Today's Single-ended and Differential Icons for SCSI

Proposed LVD and Universal Icons for SCSI

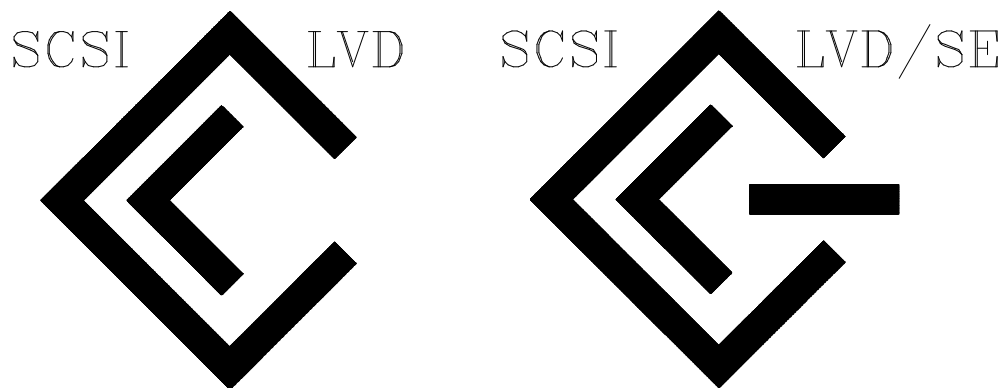
The bottom icons are proposed for LVD and Universal. Once again, the text items should be optional and, if present, these items should not be constrained as to font and size. The LVD icon should be used for those devices that only support LVD. The LVD/SE icon should be used for those devices that support either LVD or single-ended based on the voltages present on the DIFFSENS line.
